SERVICE BULLETIN

SERVICE BULLETIN		No.: MSB-97E26-002	
		Date: 1997-09-26	
Subject: ADDITION OF FRONT AXLE SHIM TO DRIVE SHAFT		<Model> (EC,EXP)COLT (CJ0A)	<M/Y> 96-10 96-10
Group: FRONT AXLE	Draftno: 97-TA-003	(EC,EXP)LANCER (CK0A)	93-10
INFORMATION	OVERSEAS SERVICE DEPT	<i>R. Usami</i> R. USAMI - MANAGER QUALITY INFORMATION ANALYSIS	(EC,EXP) LANCER WAGON(CB0W)

DISASSEMBLY AND REASSEMBLY

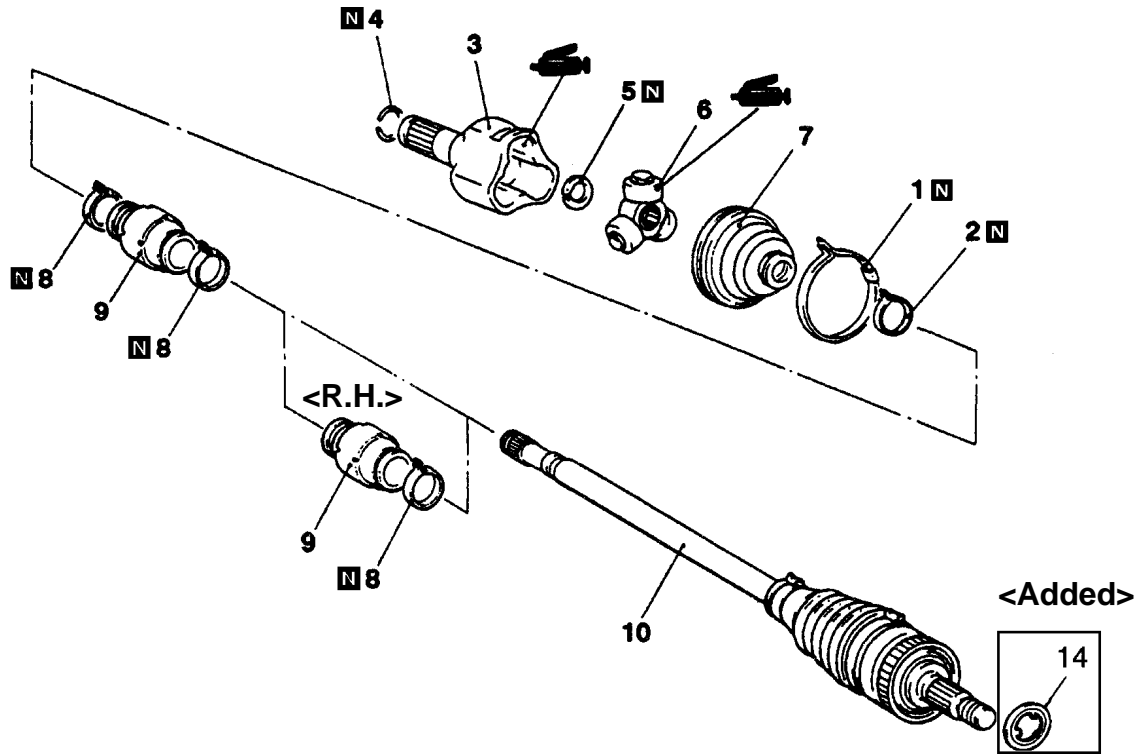
The front axle shim has been added to the axle hub end of the front drive shaft. This has brought about a change in the Disassembly steps.

14. Front axle shim **<Added>**
